DESIGN REVISIONS- NOVEMBER 2019 DRB

DESIGN REVISIONS- DECEMBER 2019 DRB APPROVAL + CURRENT PROPOSED PLANS

NEW RESIDENCE
420 SOUTH HIBISCUS DR.
MIAMI BEACH, FL 33139

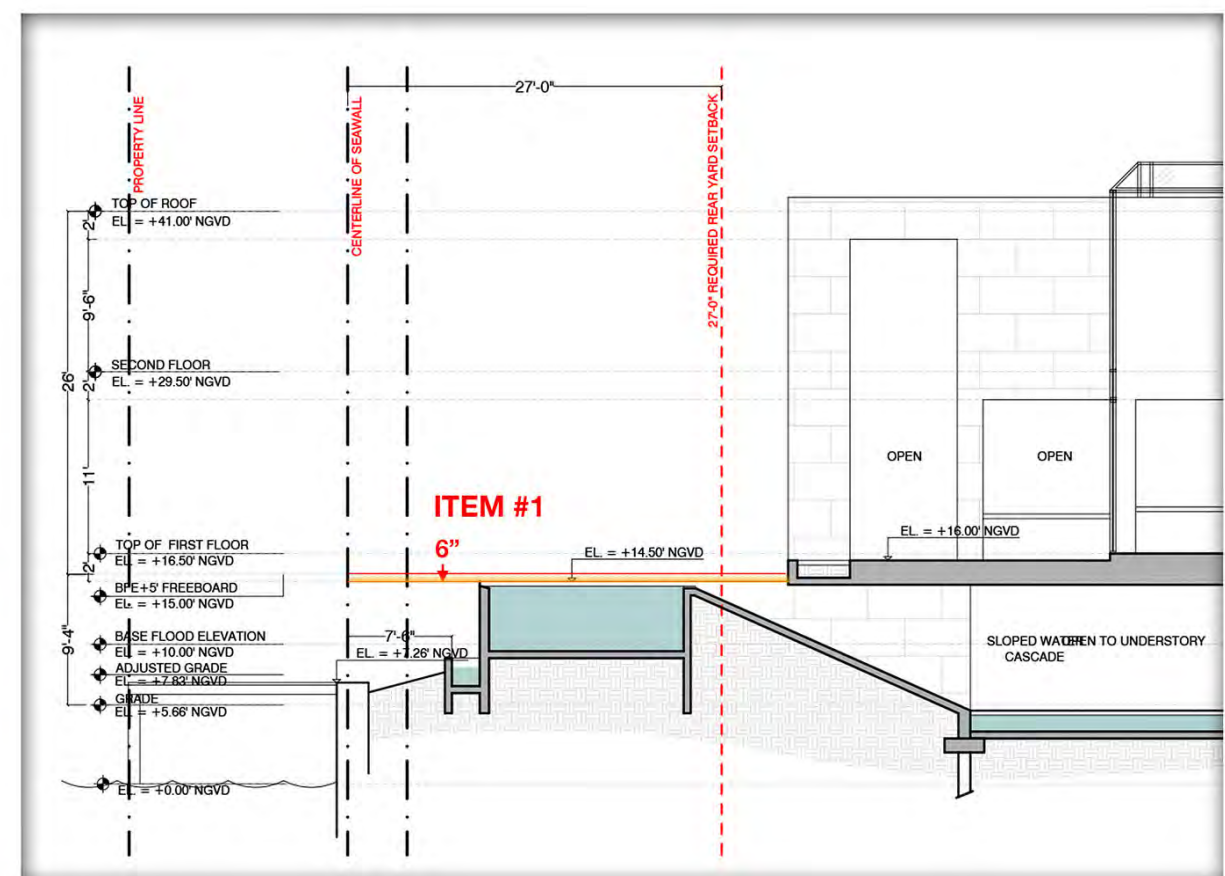
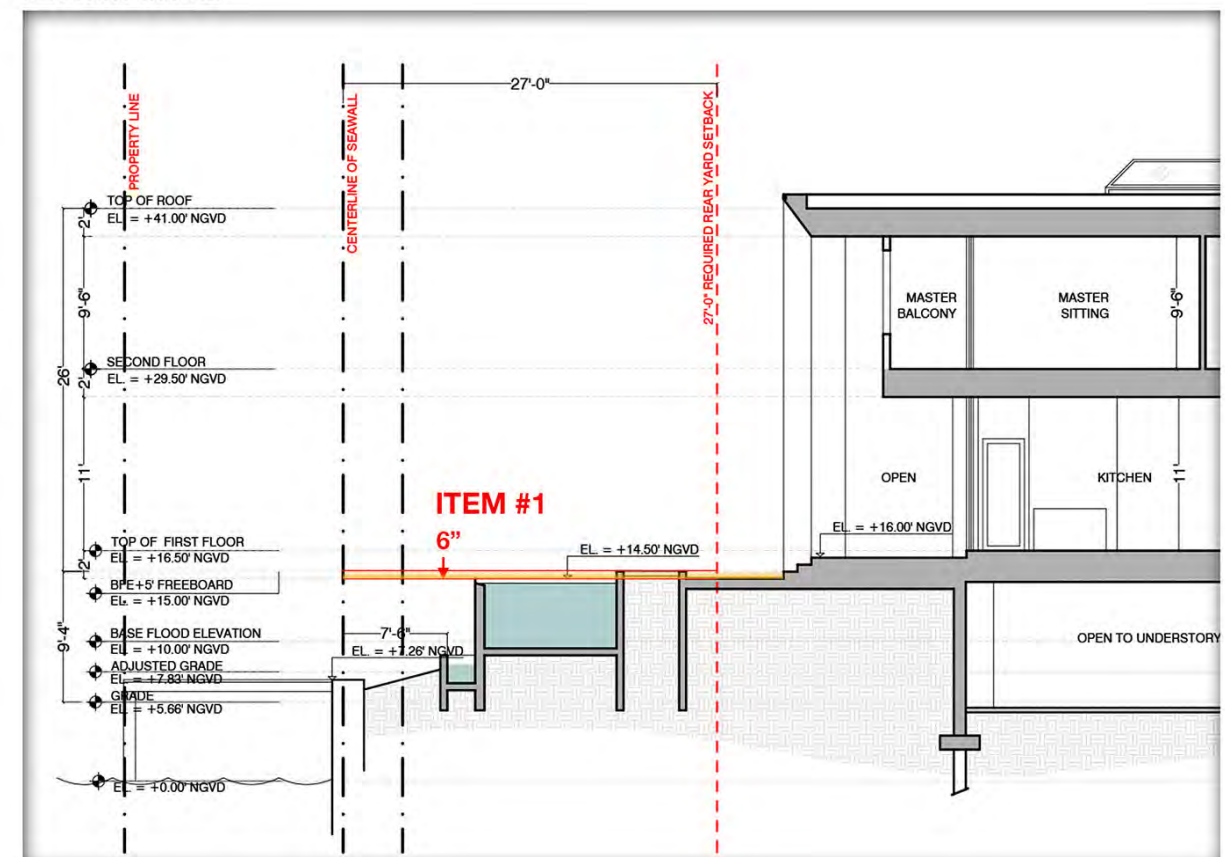
- ITEM #1: REAR POOL AND POOL LAWN TERRACE LOWERED 6\"/>

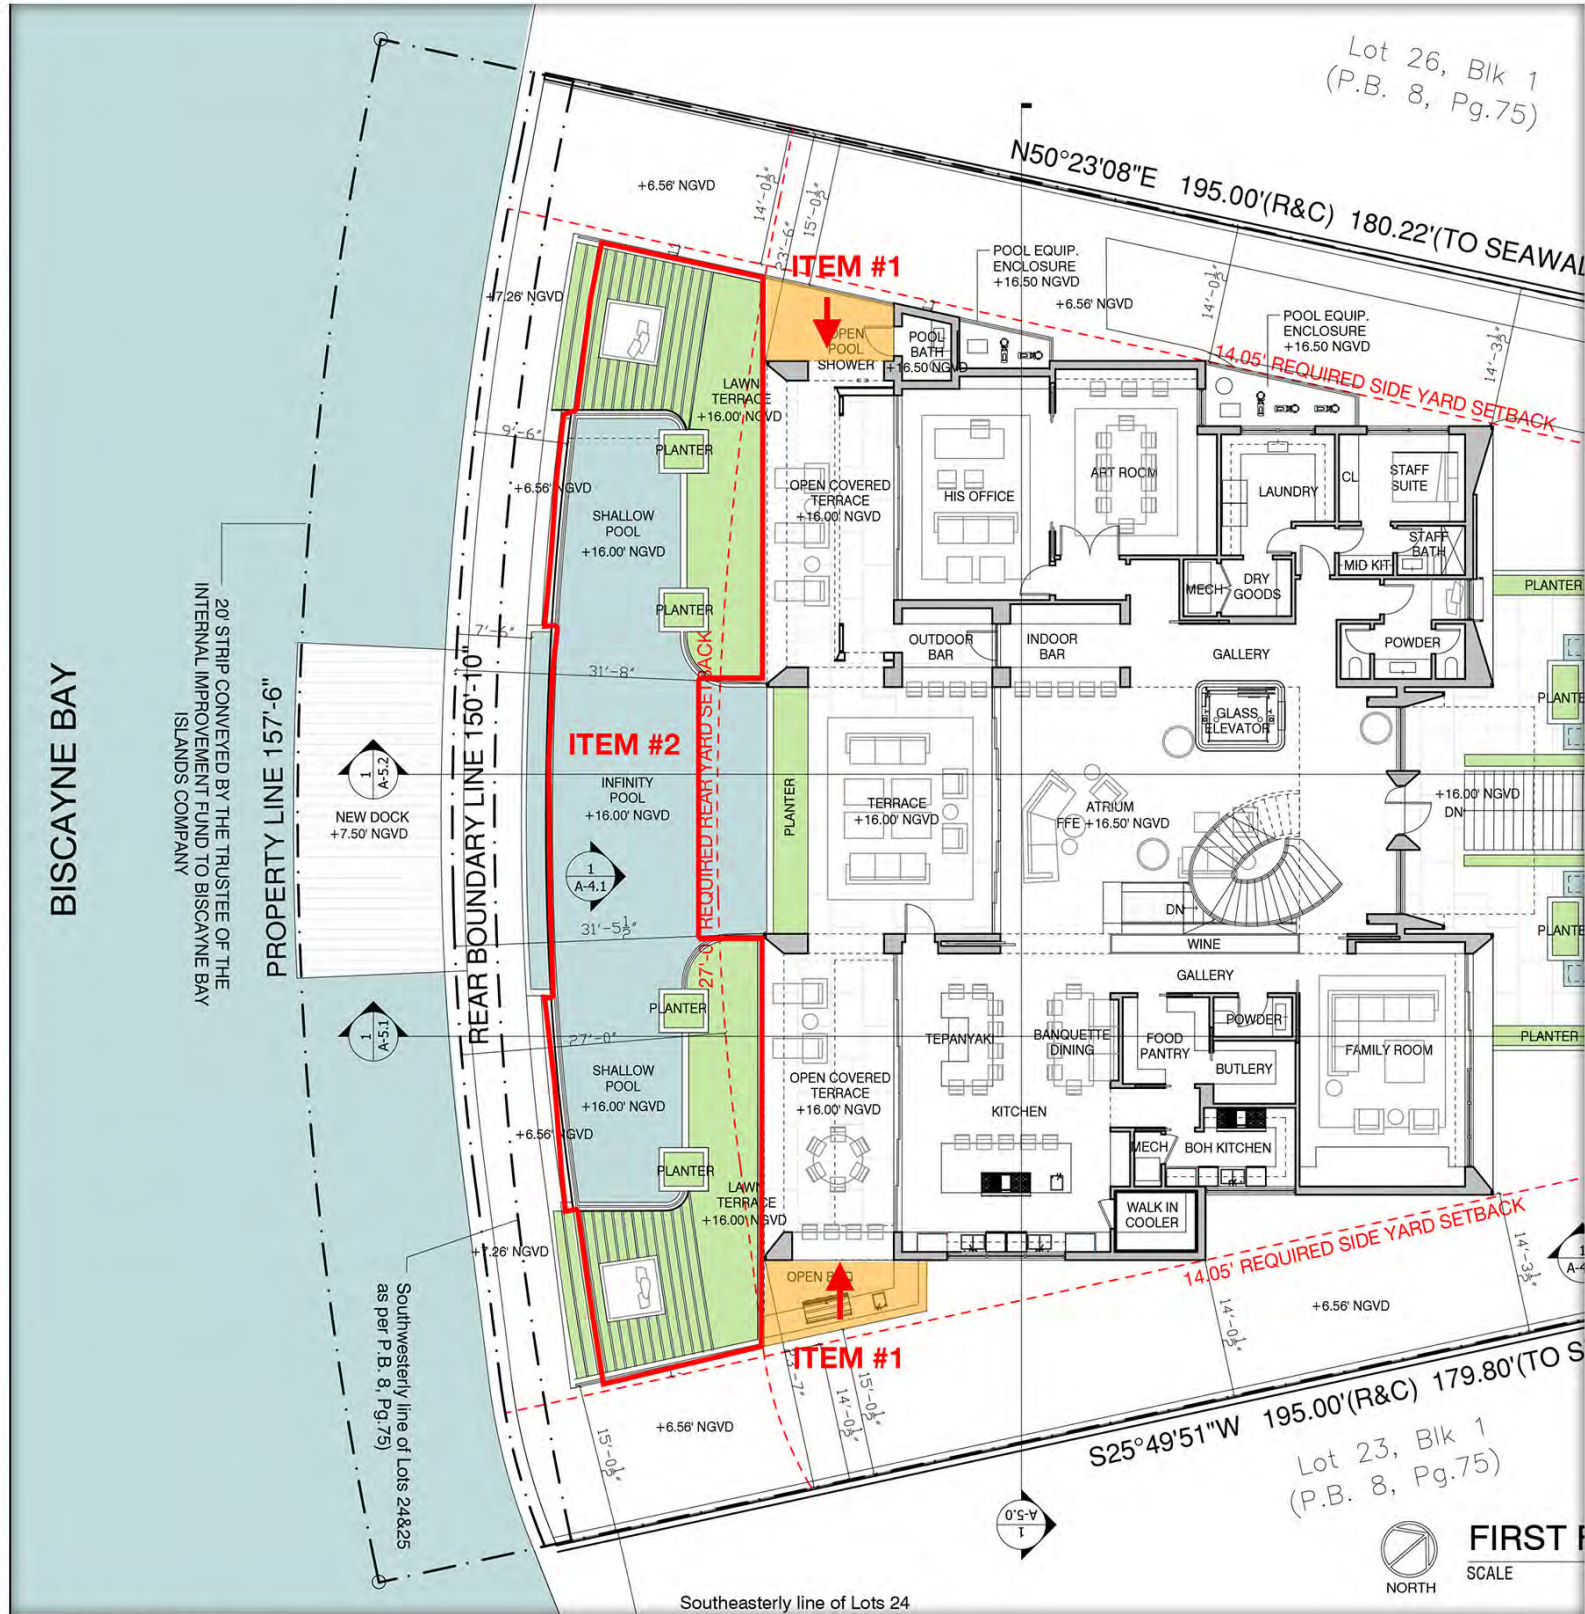
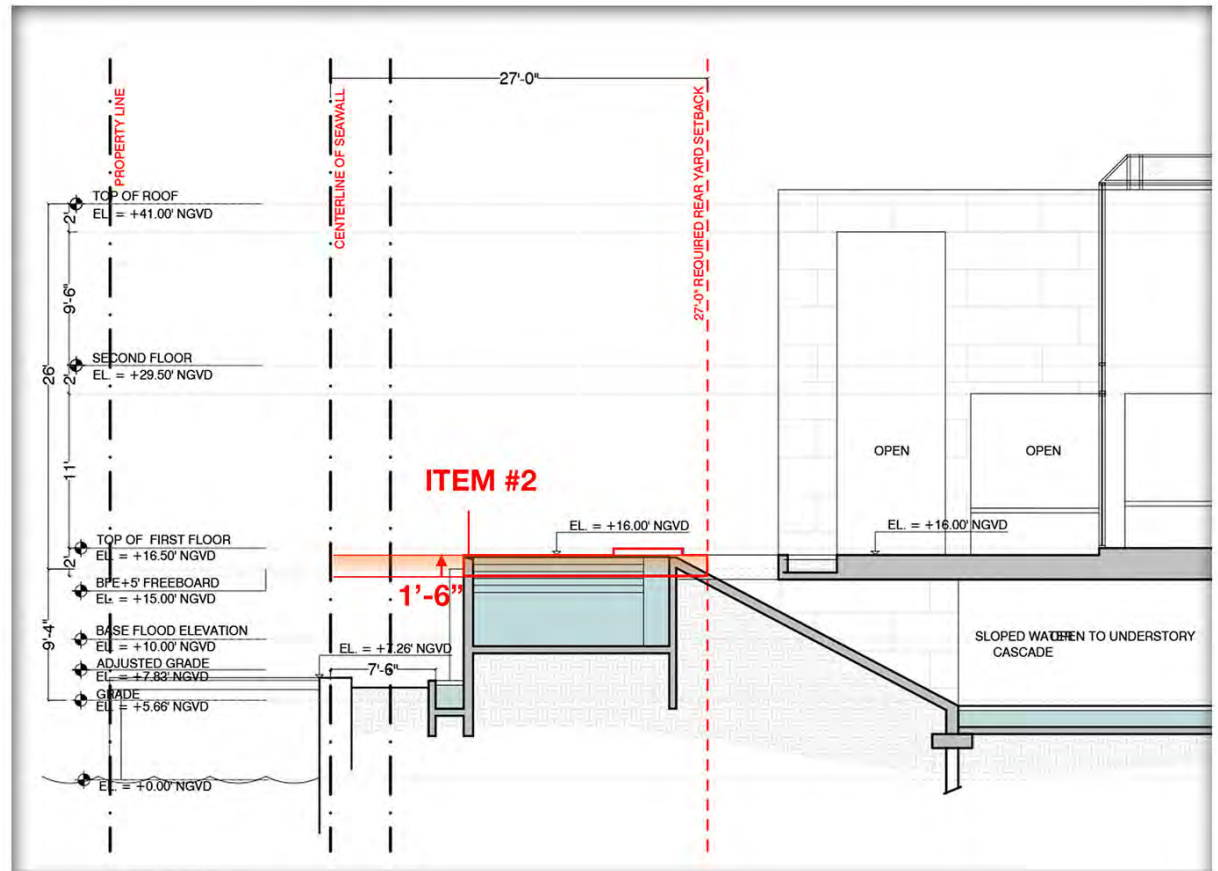
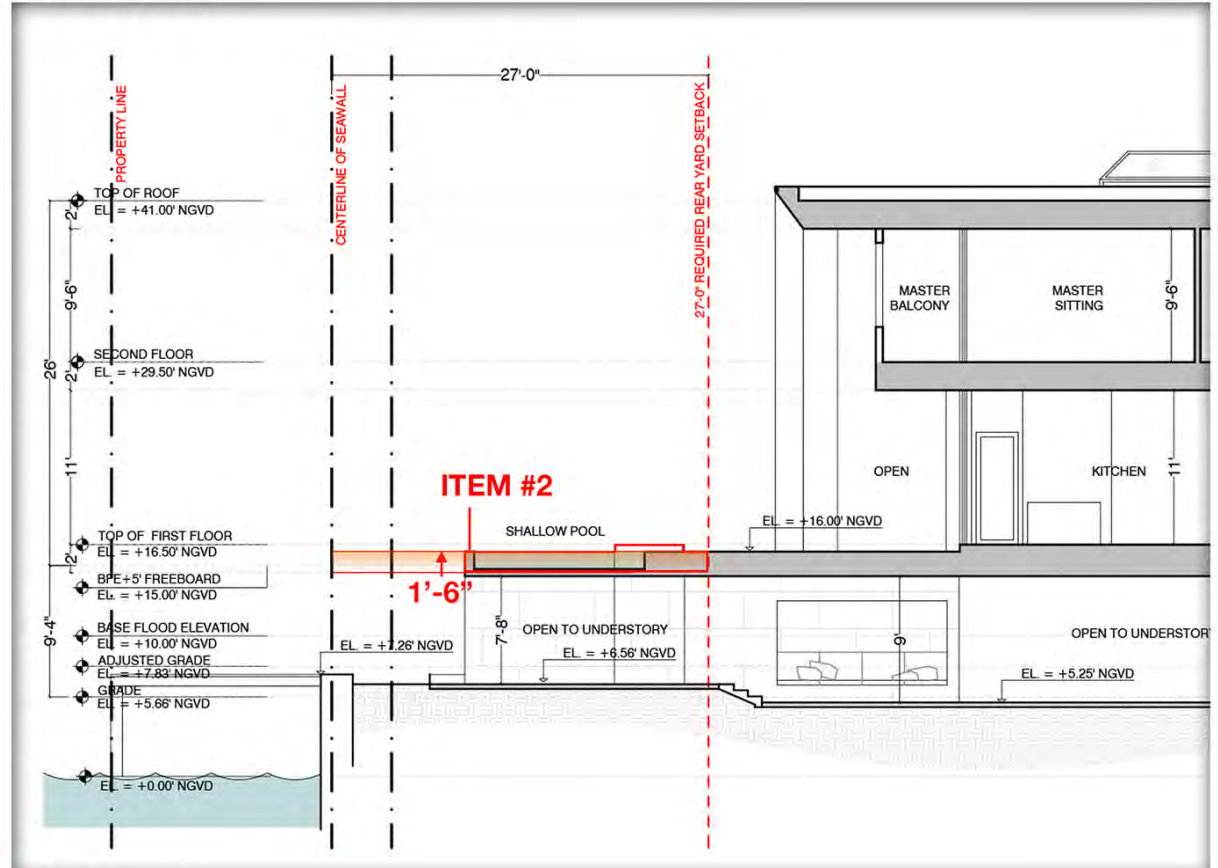
ITEM #1: BOTH SIDES OF THE REAR COVERED TERRACES MOVED INWARD TO ALIGN WITH THE EXTERIOR SIDE WALLS OF THE HOME
ITEM #2: POOL AND POOL LAWN TERRACE RAISED 1'-6" TO ALLOW FOR THE UNDERSTORY PASS THROUGH TO THE WATERFRONT

UNDERSTORY RENDERING

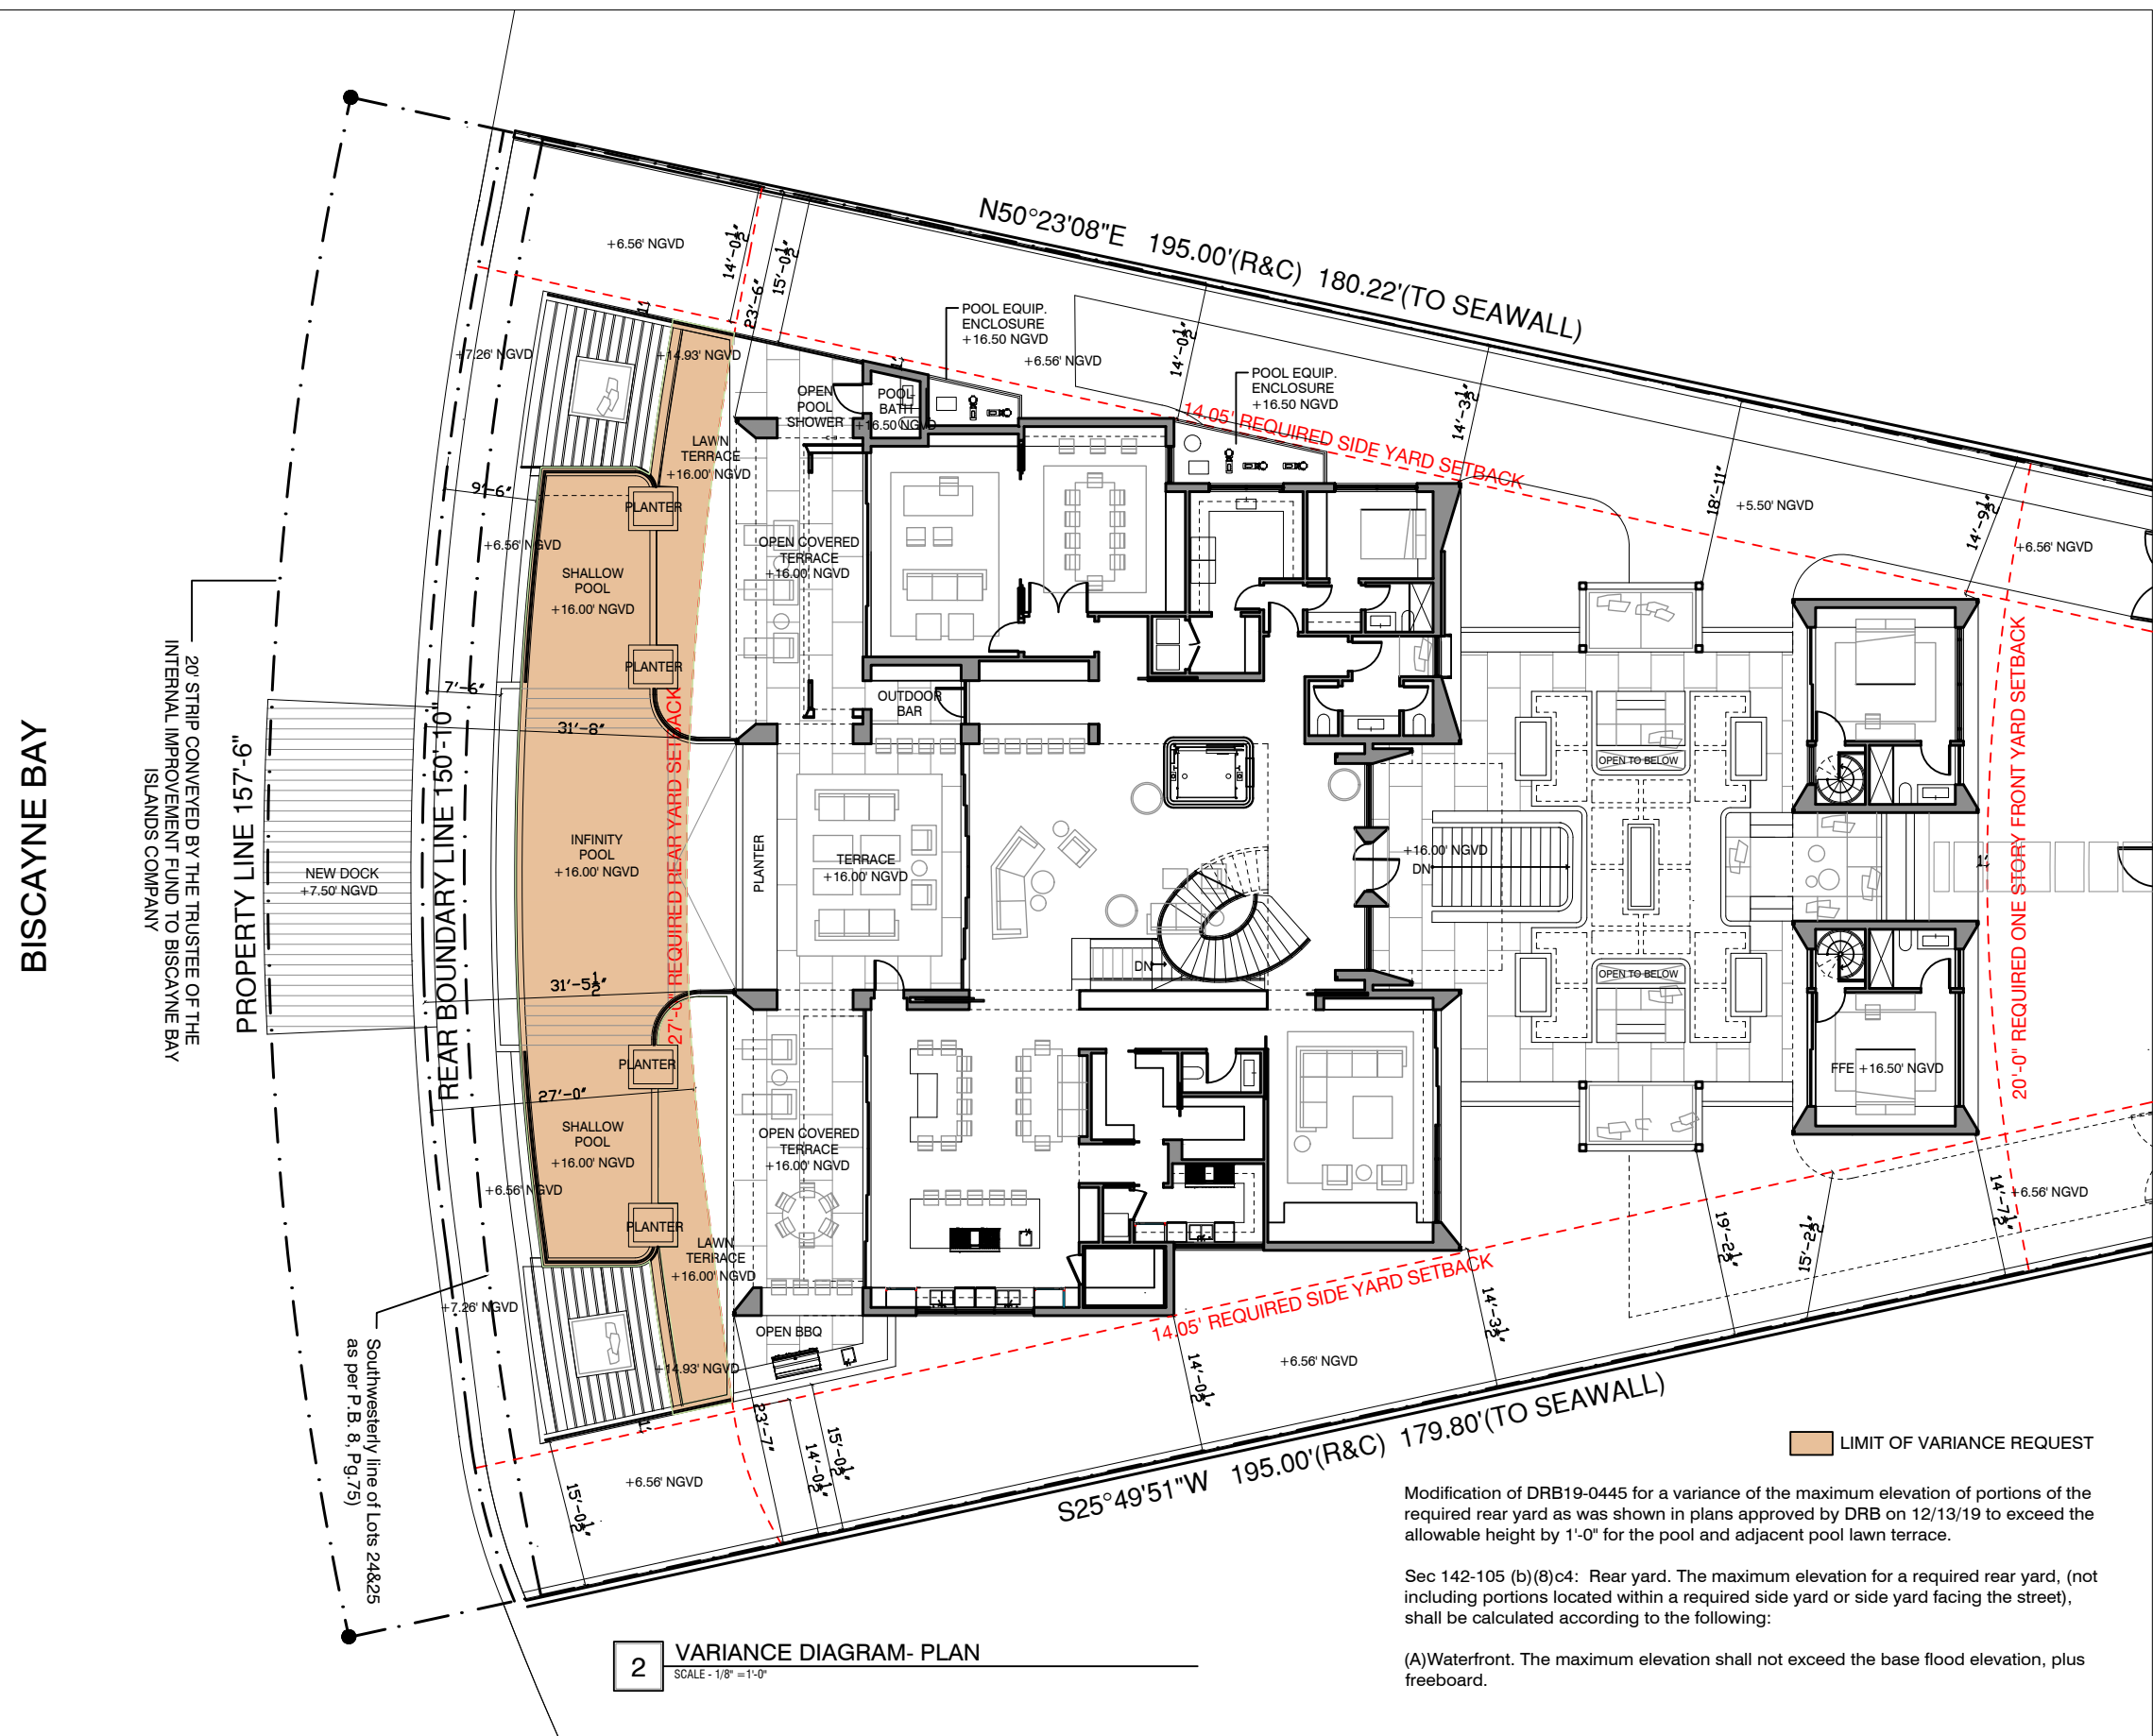
- ITEM #1: BOTH SIDES OF THE REAR COVERED TERRACES MOVED INWARD TO ALIGN WITH THE EXTERIOR SIDE WALLS OF THE HOME
- ITEM #2: POOL AND POOL LAWN TERRACE RAISED 1'-6" TO ALLOW FOR UNDERSTORY PASS THROUGH ACCESS TO WATERFRONT
- ITEM #3: NEW ACCESS TO THE WATERFRONT PROVIDED FROM THE UNDERSTORY TO ALLOW ADDITIONAL LIGHT INCOME, AIRFLOW, AND VIEWS
- ITEM #4: UNDERSTORY WALLS REMOVED TO FURTHER OPEN UP THE UNDERSTORY TO THE GARDEN
